Release 1: Initial release.

SEALING IN AUXILIARY HEATER COMPARTMENT

Prevost vehicles

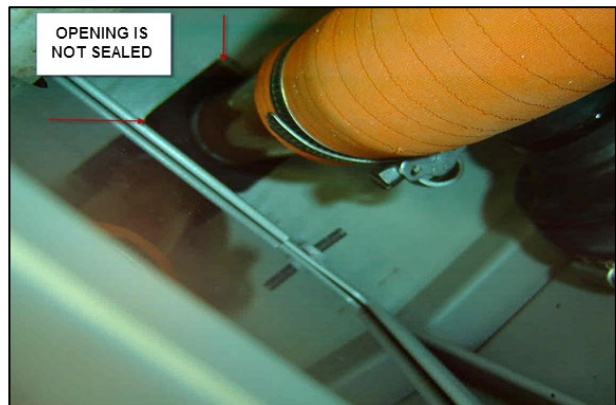
Lift the road-side wheel fender.

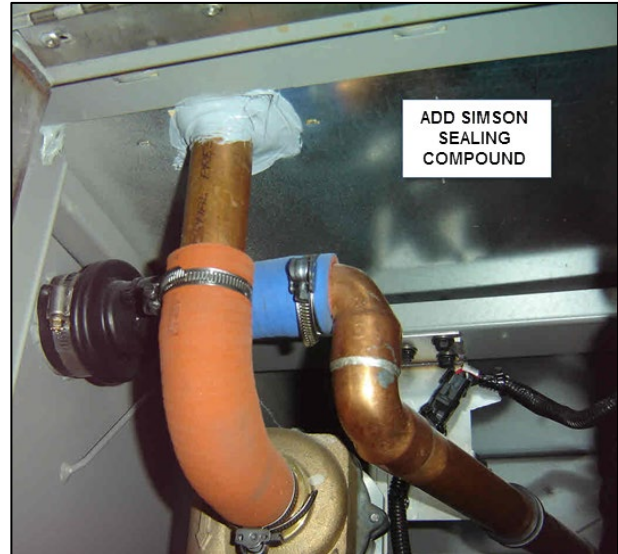
Seal the tube opening in the ceiling of the Auxiliary heater compartment with #684517 Simson sealing compound.
